Cobham SATCOM
Lundtoftegaardsvej 93 D
2800 Kgs. Lyngby
Denmark

Document Number: 95-154868-A

SAILOR VSAT **SW ver. 1.57 Build 021**

Please be informed that new software, version 1.57 build 021 for SAILOR 60 GX – SAILOR 100 GX, has been released.

Appendix I.

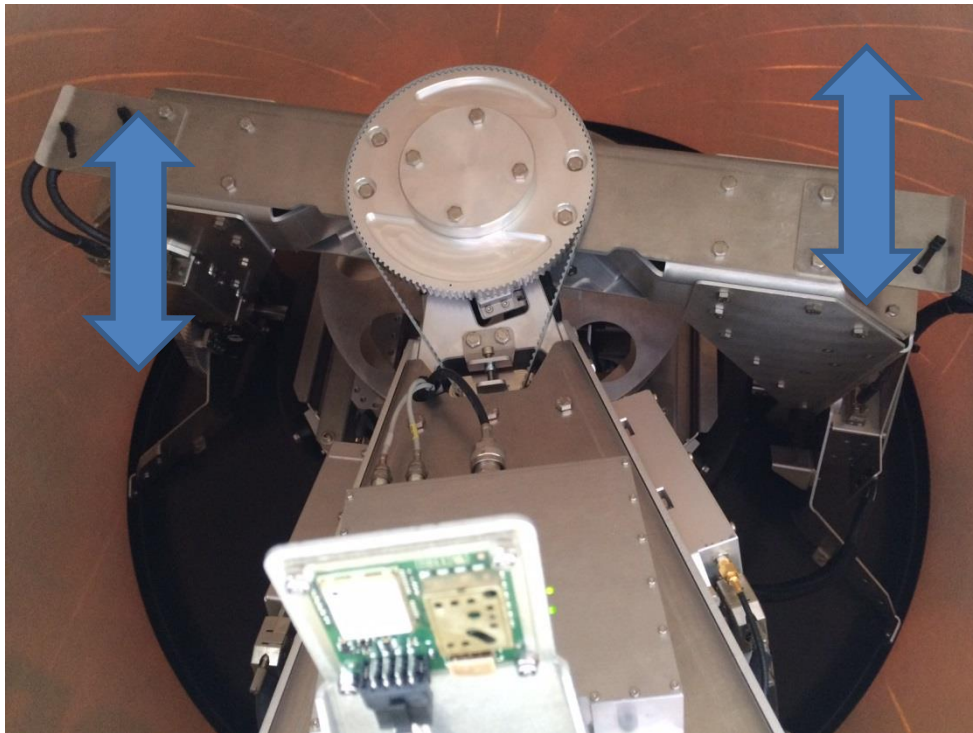
To achieve a good grease distribution in the X-elevation bearing, on vessels with a minimum of motions, the X-elevation bar is now moved $\pm 20^\circ$ within a period of 8 hours. (0 \rightarrow $+20^\circ$ \rightarrow 0 \rightarrow -20° \rightarrow 0, in a linear pattern)

That will help minimizing the friction in the bearing.

If the vessel motions increases (**roll** $> 10^\circ$) this function is stopped and the X-elevation bar is moved back to horizontal.
